Notice of Corrections to Mitsubishi General-Purpose AC Servo MR-J3-B Safety SERVO AMPLIFIER INSTRUCTION MANUAL Connection Diagram

Manual name	No Rev.	Relevant pages
MR-J3-B Safety SERVO AMPLIFIER INSTRUCTION MANUAL	SH030084-C	15-9, 15-10

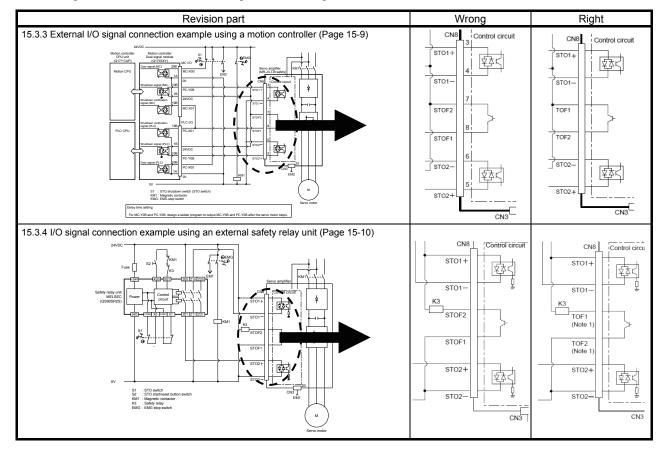
Thank you for your continued patronage of the Mitsubishi general-purpose AC servo. Some errors were found in the MR-J3-B Safety SERVO AMPLIFIER INSTRUCTION MANUAL, in which the connection diagrams are explained. The servo amplifier could be damaged if the connection is mistaken. Please check the following details, and pay special attention to the connections.

The signal name in connection diagrams is changed to as follows. STOF2 \rightarrow TOF1, STOF1 \rightarrow TOF2
